Re: Pima County Letter Dated December 17, 2015

**RESPONSE TO POWELL ET AL. (2015), "NEW ANALYSIS OF
STORMFLOW AND GROUNDWATER DATA FROM DAVIDSON
CANYON: EVIDENCE FOR INFLUENCE OF STORMWATER
RECHARGE OF GROUNDWATER"**

Project Number: 1049.91
April 19, 2016

Figure 1. Stage and Discharge Data for ALERT Gauge 4310, 7/15 – 11/25/2015

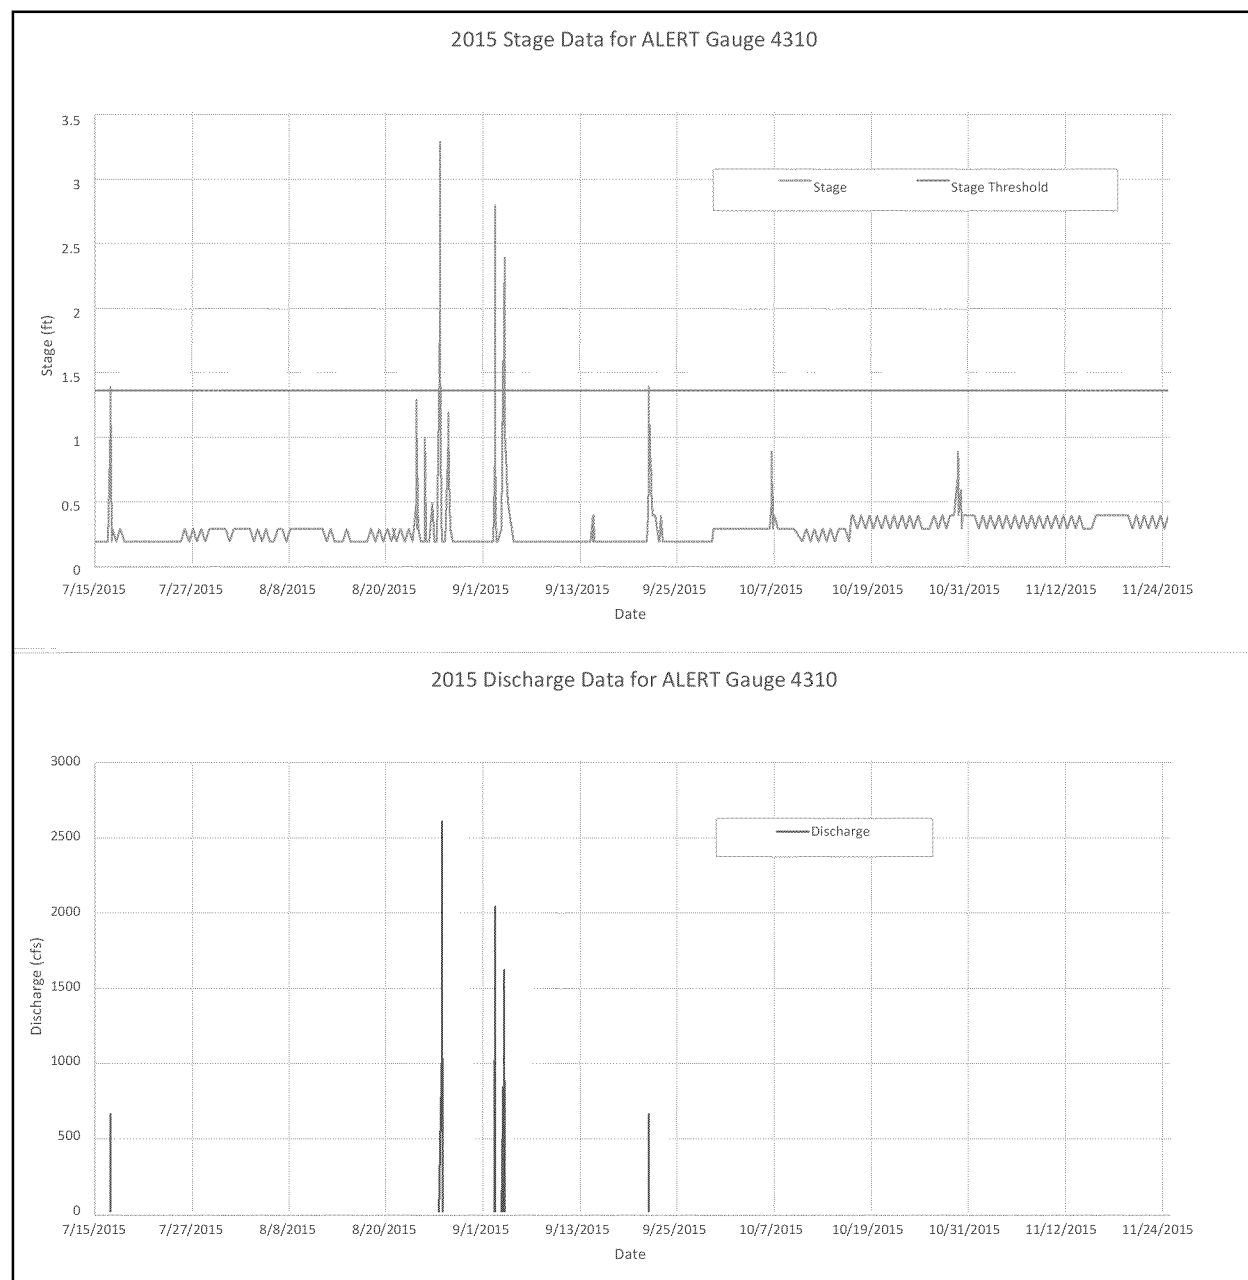
All measured stage values below 1.4 feet correspond to a reported flow of 0 cfs. The ALERT gauge data indicate that runoff conditions measured at this gauge with flows between 0 and 674 cfs are not being reported. The stage and discharge data for 7/15 - 11/25/2015 are presented in **Figure 1**. The stage at 1.4 feet where non-zero discharge is reported (stage threshold) is also shown. Small stage values (e.g., < 0.5 feet) and variations (e.g., +/- 0.1 foot) shown in the stage data presented in **Figure 1** likely represent common sensor measurement errors that can be caused by extreme heat or long periods of dry conditions.

Investigation into the measured stages during 7/15 – 11/25/2015 show that non-zero estimates of discharge were reported for only five (5) runoff hydrographs (shown in green in **Figure 1**) in that period. There were an additional six (6) events with measured stages greater than or equal to 0.5 feet but less than 1.4 feet during 2015 (shown in blue in **Figure 1**). For these six events, discharges of zero (0) cfs were provided in the ALERT data record.

All flows from 7/15 – 11/25/2015 with measured stages less than 1.4 feet were unaccounted. This includes three (3) events between 1.0 foot and 1.3 feet. Discharge during these smaller events is

significant, considering that the rated discharge for a stage of 1.4 feet is 674 cfs. The cumulative volume of runoff from hydrographs with stage magnitudes less than 1.4 feet were not included in the runoff volume computations presented in Powell et al. (2015). The total volume calculated does not account for all runoff at the gauge, and underestimates the actual runoff volumes during the 2015 analysis period. Therefore, Powell et al. (2015) is overestimating the flow contribution from Barrel Canyon. The true runoff contribution of Barrel Canyon as a fraction of Davidson Canyon runoff for these specific flow events cannot be determined with the data available.

Figure 2. Measured Precipitation

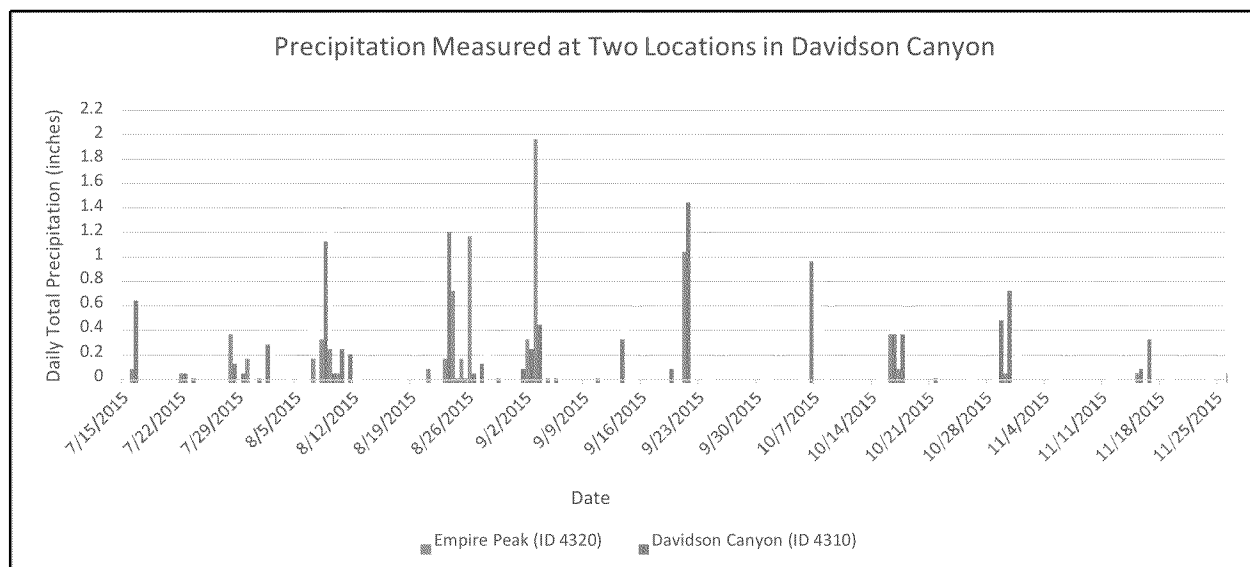
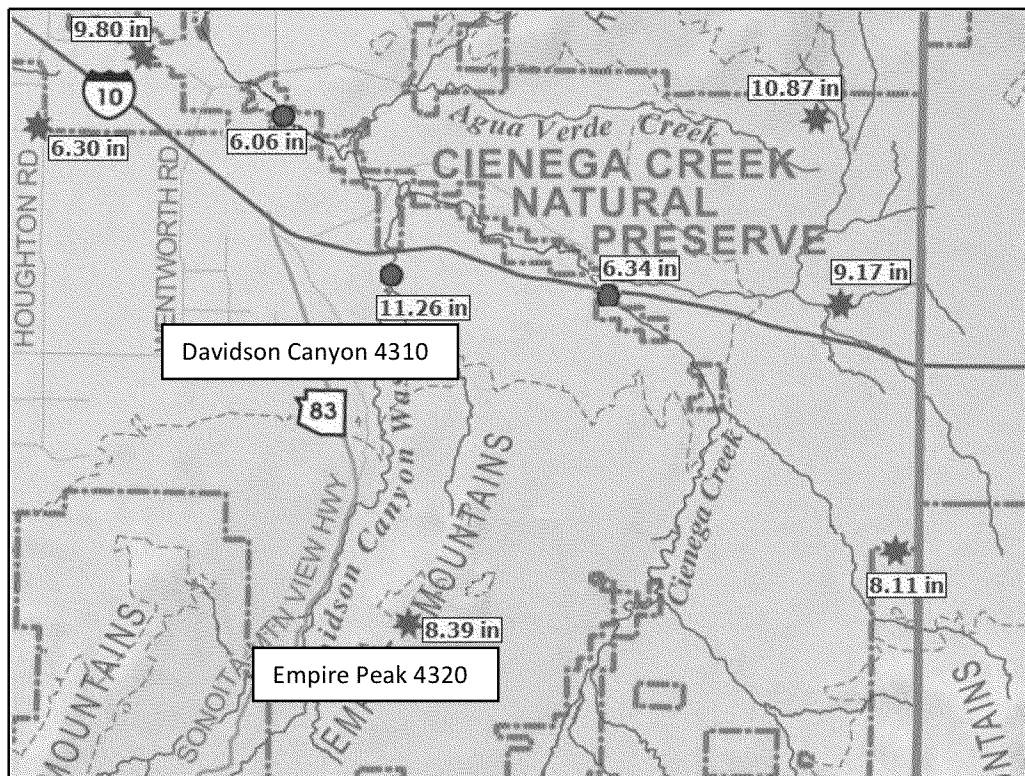
In addition, the higher elevation gauge (Empire Peak) measured less precipitation during this time in 2015 (**Table 3** and **Figure 3**). The two ALERT gauges lie within the Davidson Canyon watershed at elevation differences greater than 2,000 feet (**Table 2**). Rainfall totals during July 15 through November 25, 2015 indicate that the lower elevation Davidson Canyon ALERT Gauge 4310 measured almost 3 inches more rainfall (35 percent greater) than the higher elevation Empire Peak gauge 4320 (**Figure 3**). **Figure 3** also demonstrates variability in rainfall totals measured at other station locations near Davidson Canyon watershed. During this very narrow time period the seven (7) other nearby rain gauges also did not show the orographic precipitation effect stated by Powell et al. (2015).

So we have demonstrated here that, while the Forest Service FEIS (USFS 2013) did indeed address the orographic effects on rainfall variability, the short-term dataset shows variability that does not always adhere to the expected relationship.

Figure 4. Daily Total Runoff

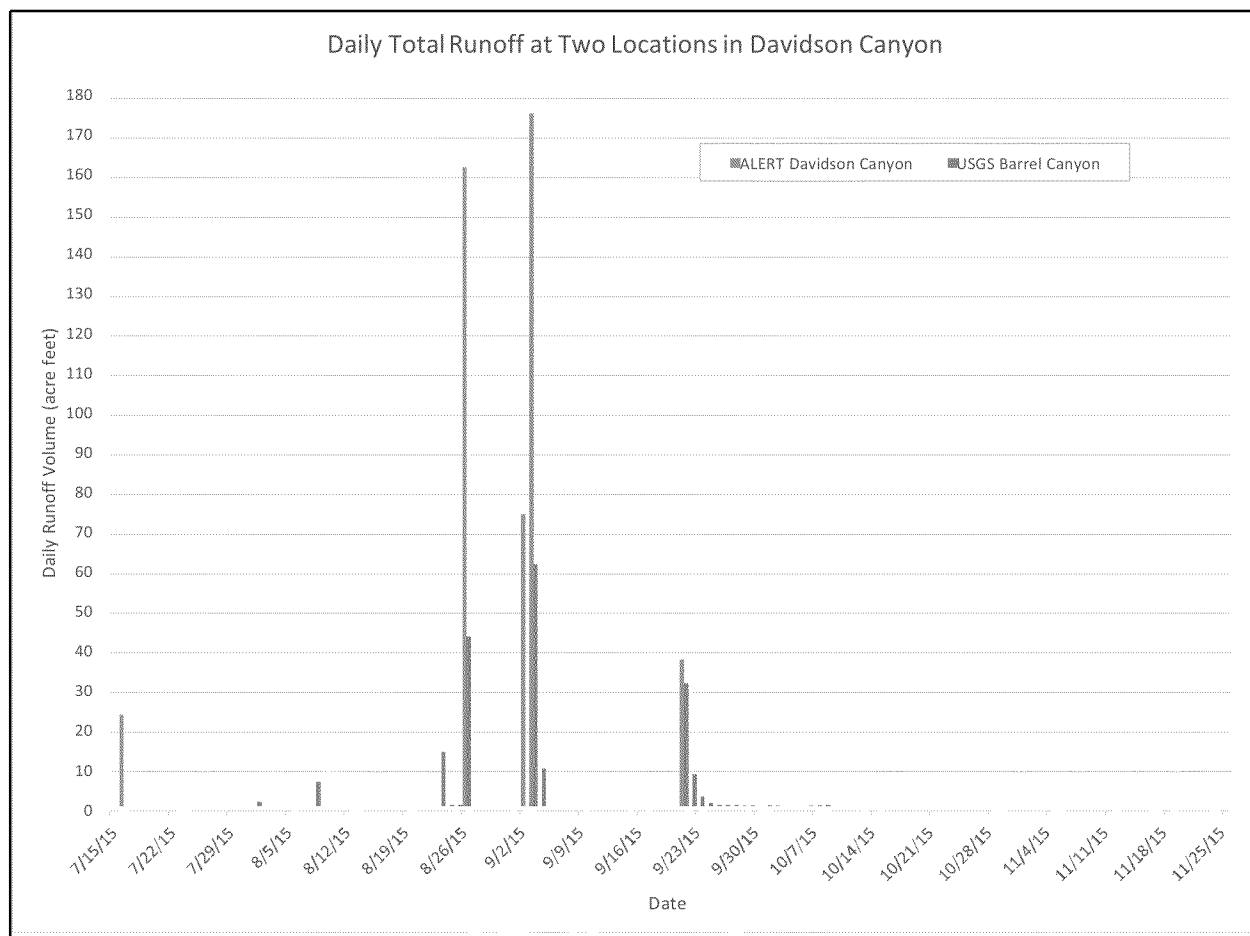
Total runoff volumes from July 15 through November 25, 2015 at the two gauges are shown graphically in **Figure 4**, which demonstrates the variability in timing of runoff between the two gauges. There were occurrences of runoff measured at the Barrel gauge on days when no runoff was measured at the Davidson gauge. Conversely, there were days when the Davidson gauge measured runoff when no runoff was measured at the Barrel gauge. There are only three (3) measured runoff events during this time period when runoff was measured at both gauges on the same day.

The number of days with measured runoff for the same time period are shown in **Table 4**. There were more days with measured runoff at the Barrel Canyon gauge as compared to the Davidson Canyon ALERT gauge. This may be due, in part, to runoff with stages less than 1.4 feet not being recorded at the Davidson Canyon ALERT gauge.

Figure 5. Depth to Groundwater at Well D-16-17 31DCB (Davidson Canyon #2)

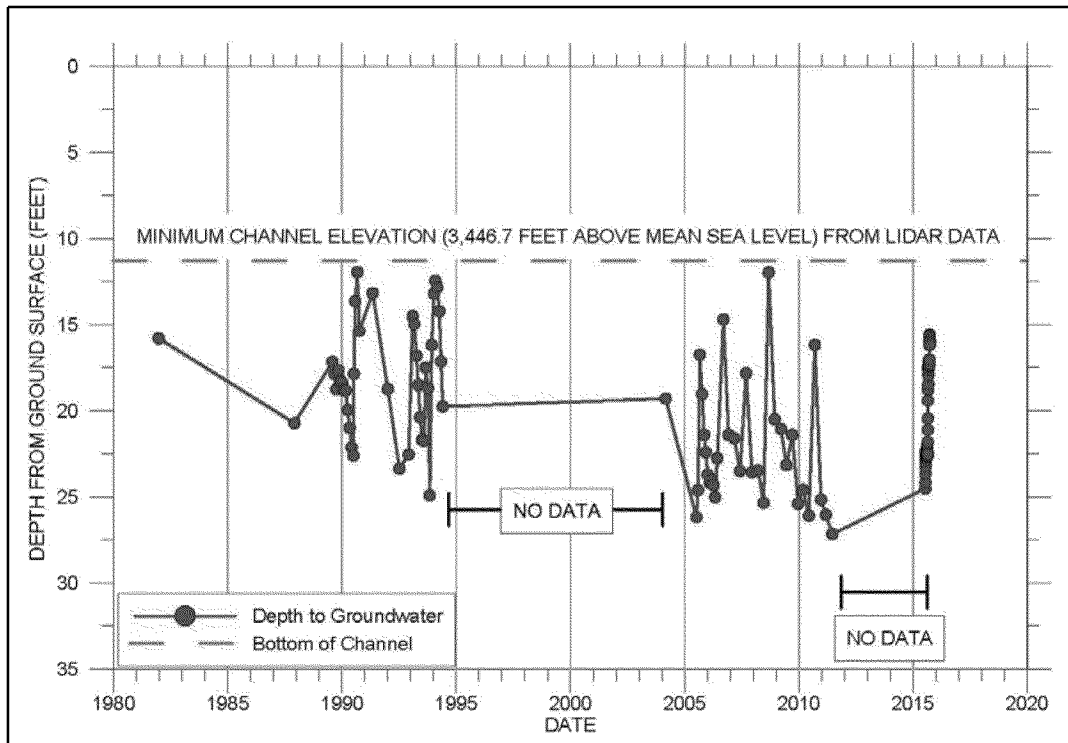
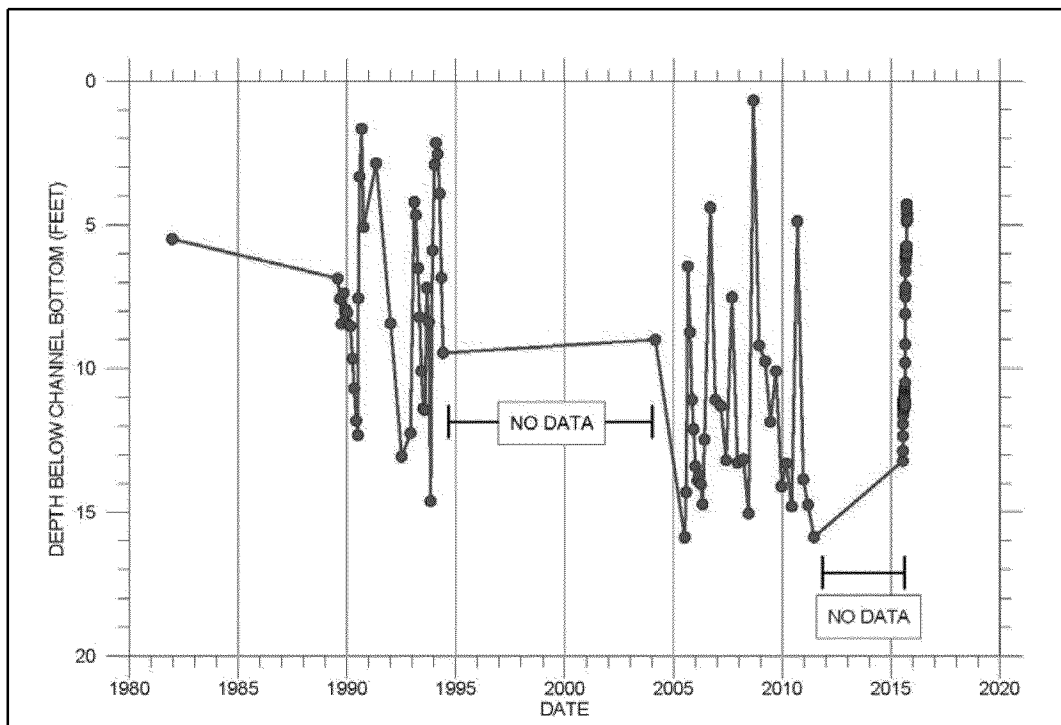
Given the location of the Davidson #2 Well in relation to the stream channel, and the fact that the well measures shallow alluvial groundwater, a correlation between stream flow and shallow groundwater level is not only anticipated, it is axiomatic. Indeed, ADWR monitors a series of wells fitted with transducers throughout the state, located adjacent to washes or major river channels, and all of these wells exhibit this same runoff-recharge relationship, e.g. ADWR INDEX well (D-16-16) 14CAC located near Pantano Wash.

Powell et al. (2015) contend that, "...analysis of the impacts of the proposed Rosemont project on Davidson Canyon and Cienega Creek does not take into account [the runoff-recharge] relationship" in Davidson Canyon, supporting their thesis that impacts of the Rosemont Project on Davidson Canyon and Cienega Creek have been "understated" in the Forest Service FEIS (USFS 2013) and the ADEQ 401 water quality certification (ADEQ 2014a). However, this is demonstrably untrue.

Figure 7. Davidson Canyon *flow length* versus *depth to water* at well Davidson #2. Data from Figure 5 of Powell et al. (2014).

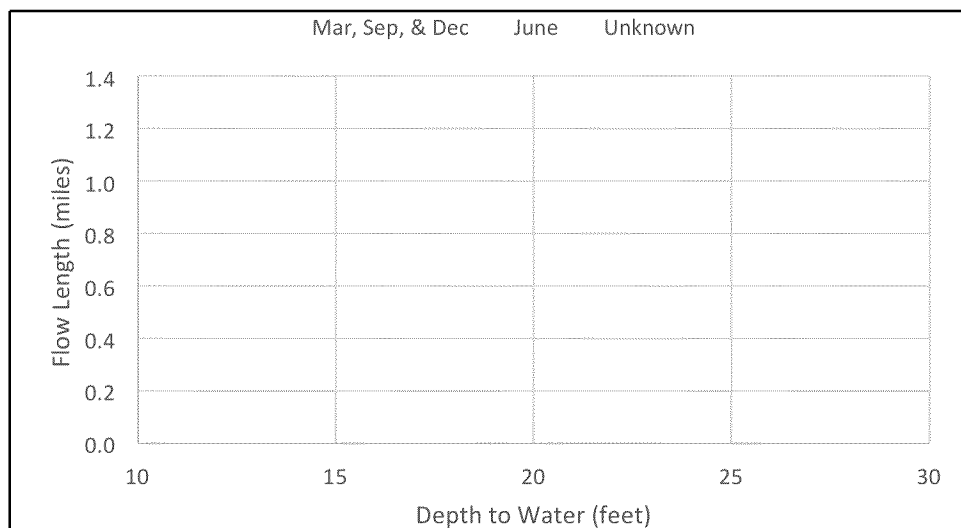
Figure 7 shows the data from Figure 5 of Powell et al. (2014). There are twenty-six data points, with eight from June plotted in red, and one from an unknown date plotted as a green square. The *flow length* is zero for nine of the sample points. For the nine sample points with zero *flow length*, the Powell et al. (2014) depth to water ranges from 20.2 feet to 29.5 feet, with a range of 9.3 feet. The range of *depths to water* for all sample points is 17.5 feet (12.0 to 29.5 feet). The range of *depth to water* for sample points with zero *flow length* covers over half the total range for the sample.

The sample data were modeled using simple linear regression instead of a model that accounts for censored data. This means that any predictions, such as the 30 percent reduction in *flow length* due to a 0.98-foot increase in depth to water (Powell et al. 2014), are invalid.

Figure 8. Davidson Canyon *flow length* versus *depth to water* at well Davidson #2. Data from Figure 5 of Powell et al. (2014).

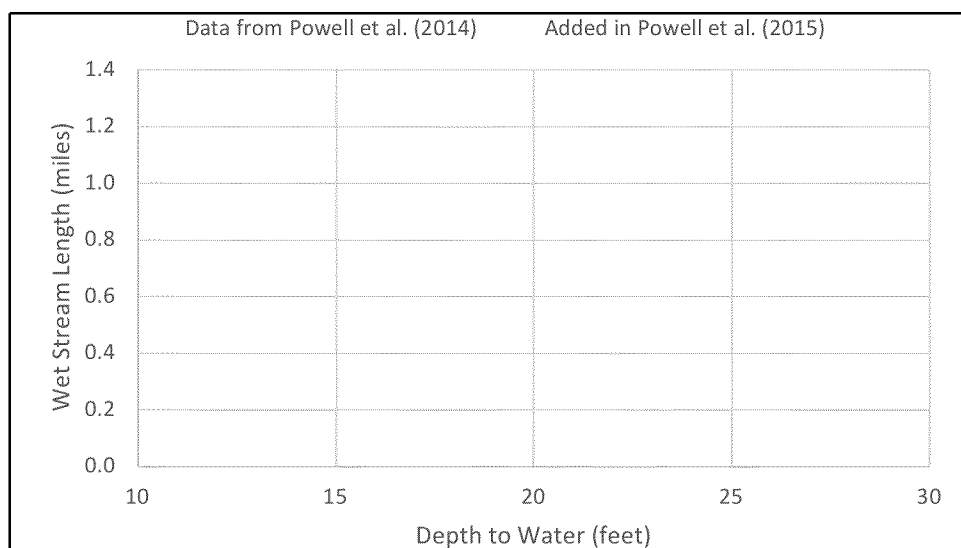
Figure 8 shows the data from Figure 6 of Powell et al. (2015). The points in **Figure 8** are the same as **Figure 7** except that two points (plotted in red) have been added¹. The data in **Figure 8** still include nine sample points with flow length equal to zero, and cannot be modeled using linear regression as was done in both Powell et al. (2014) and Powell et al. (2015).

¹ Powell et al. (2015) states that three points were added since Powell et al. (2014), but only two new points can be seen in Figure 6 of Powell et al. (2015).
